NOTICE OF ADDENDUM
ADDENDUM NO. 2
CONTRACT NO. 8292

HAMMERSLEY AVENUE ASSESSMENT DISTRICT – 2018

HAMMERSLEY AVENUE ASSESSMENT DISTRICT - 2019

CONTRACT NO. 8292

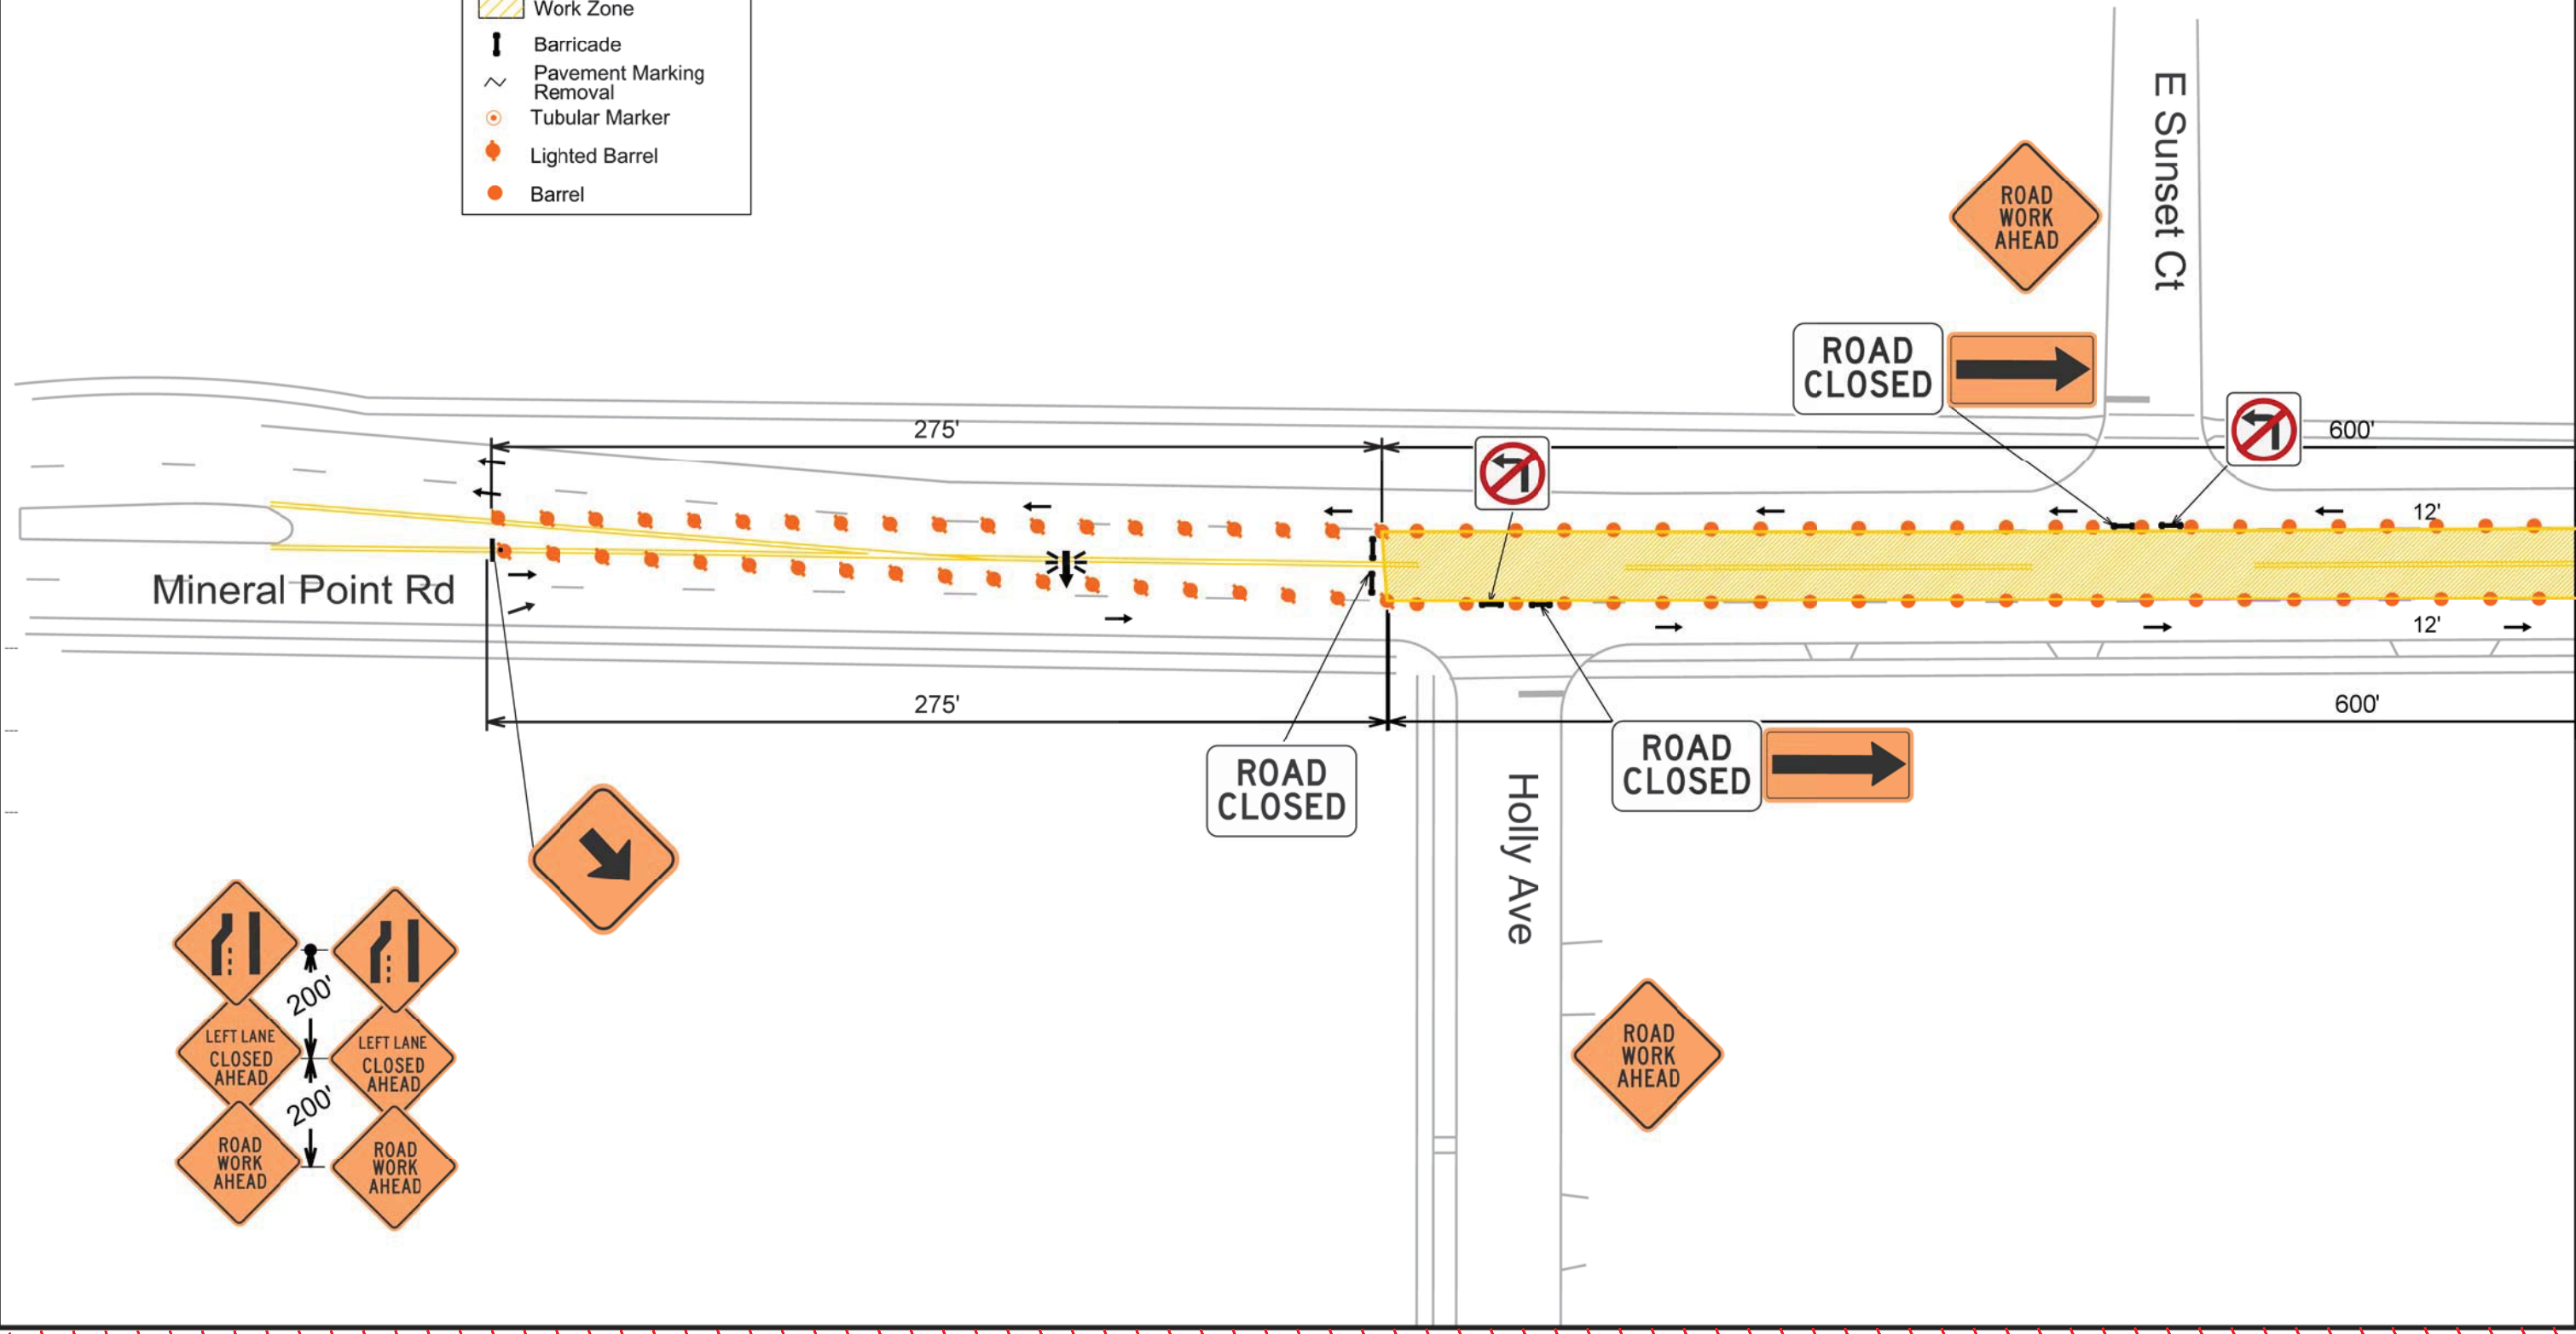
TC-3 & TC-4: Changed phase 2 to show inbound and outbound inside lanes closures.

REVISION 1/4/19 AH
-changed phase 2 to show inbound & outbound inside lanes closed

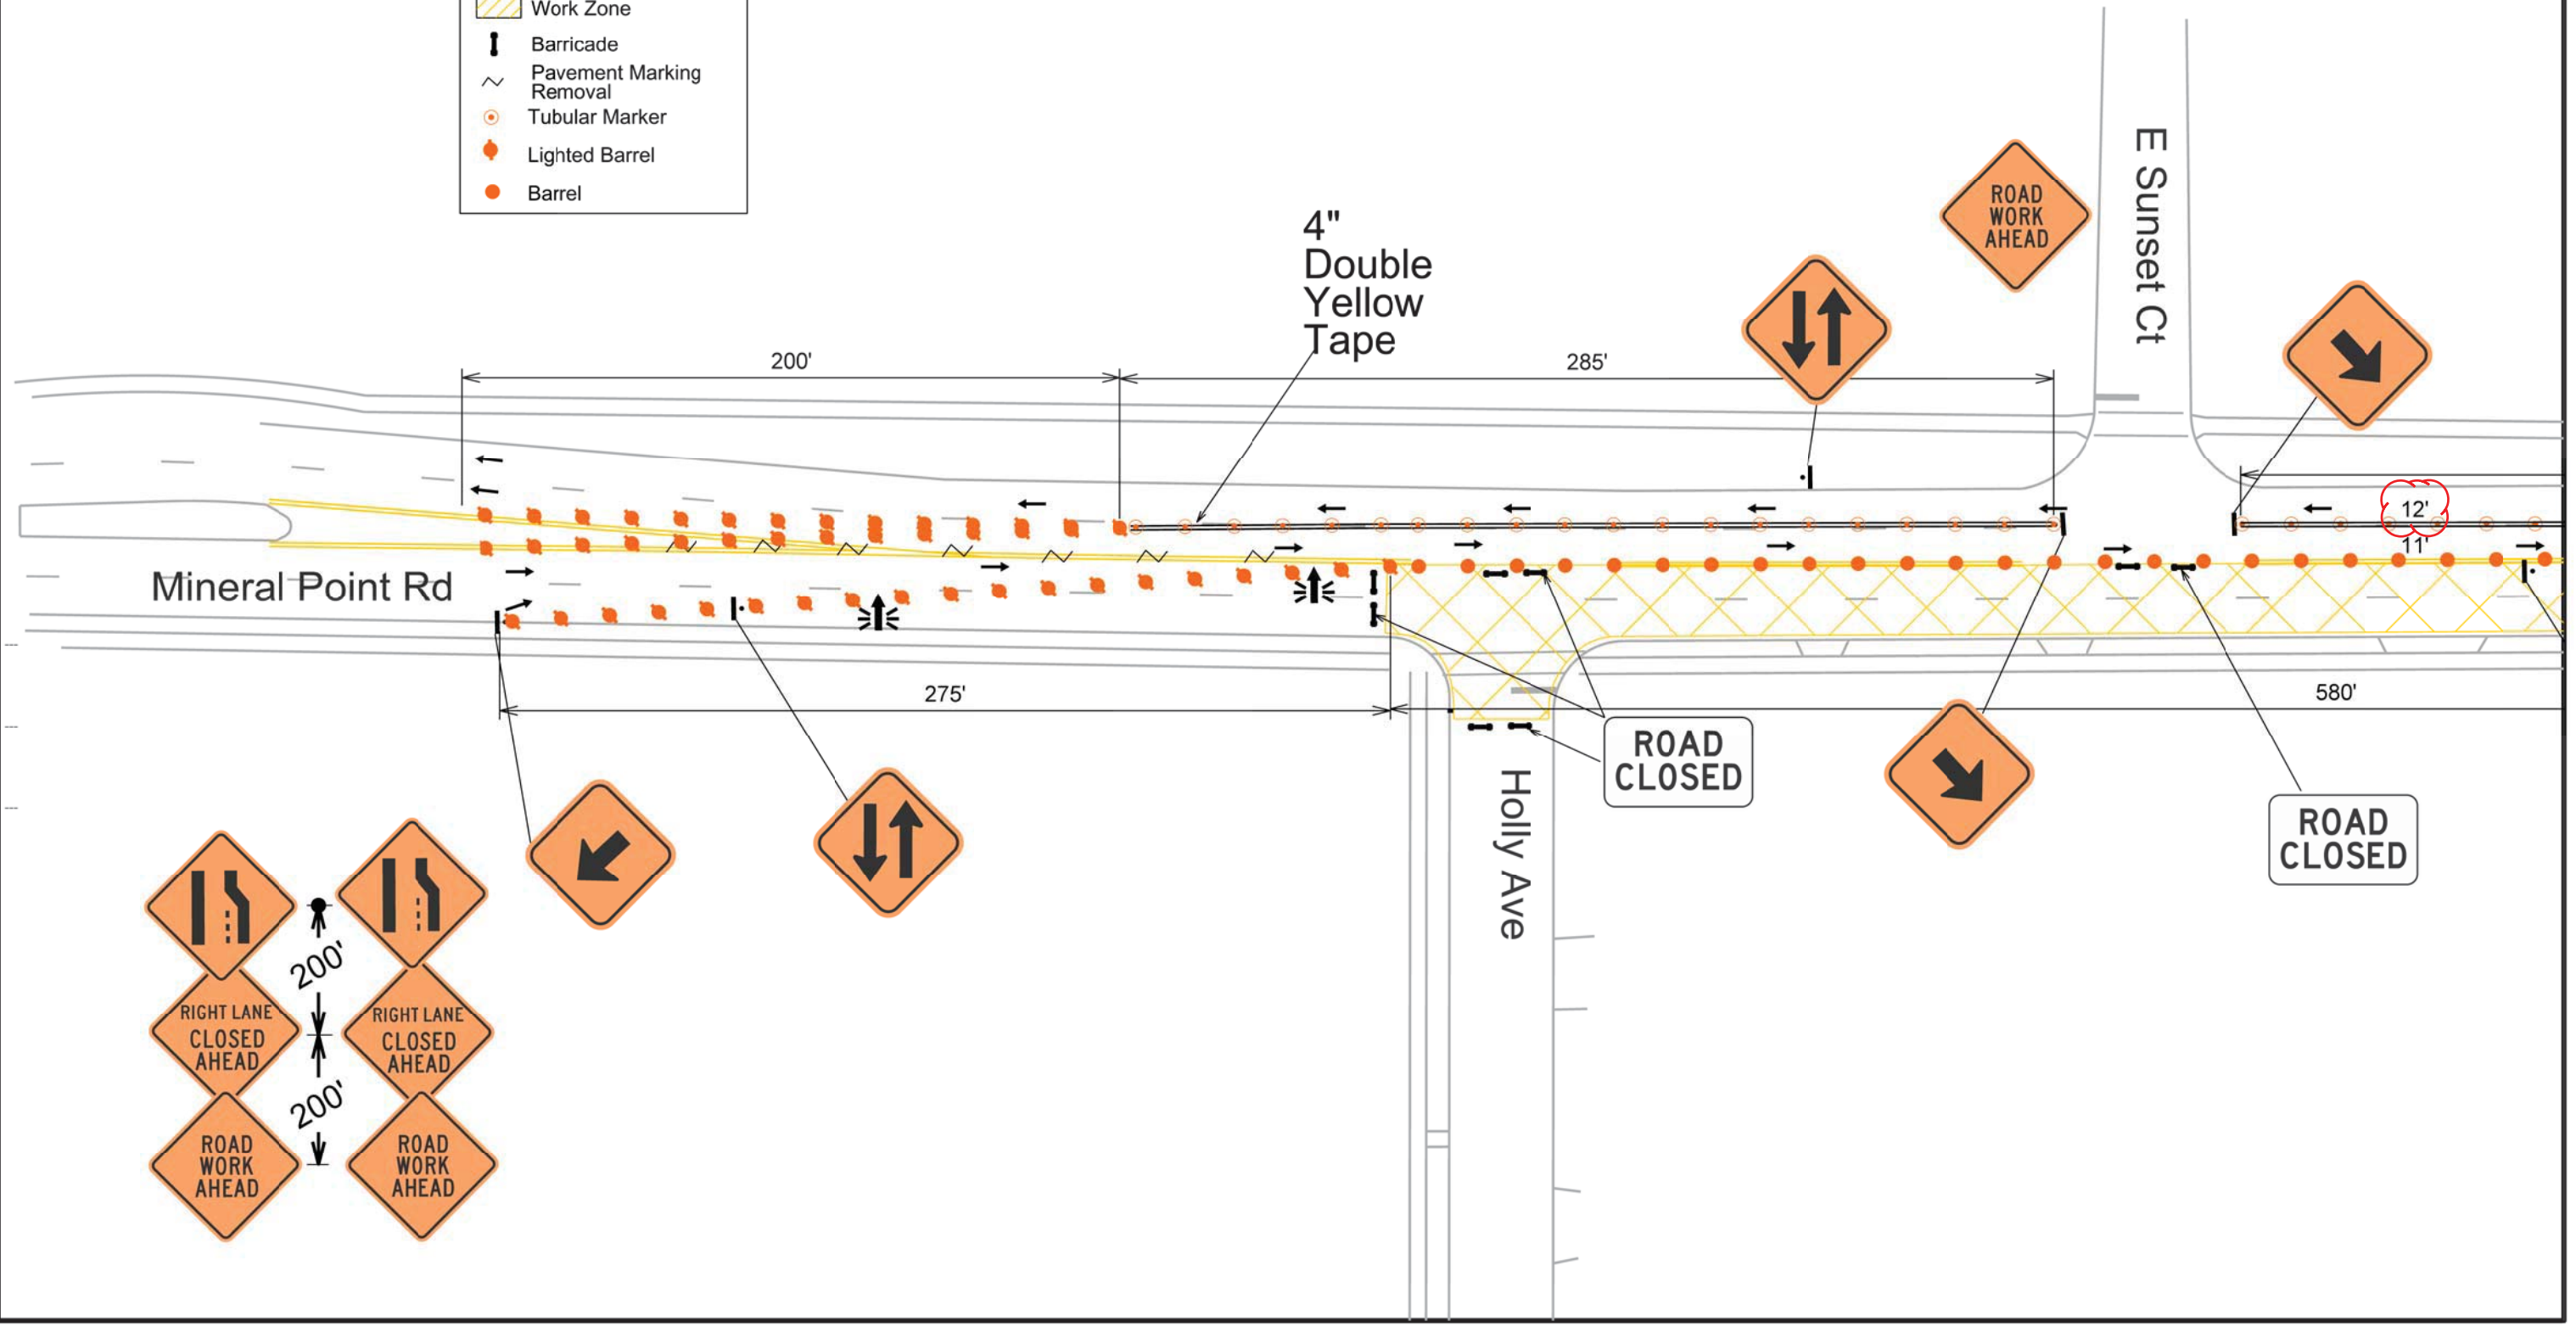
TC-5 & TC-6: Added phase 3 to show inbound inside and outside lane closures. Change outside lane width to 12 feet.

REVISION 1/4/19 AH
-added phase 3
-changed outside lane width to 12 feet.
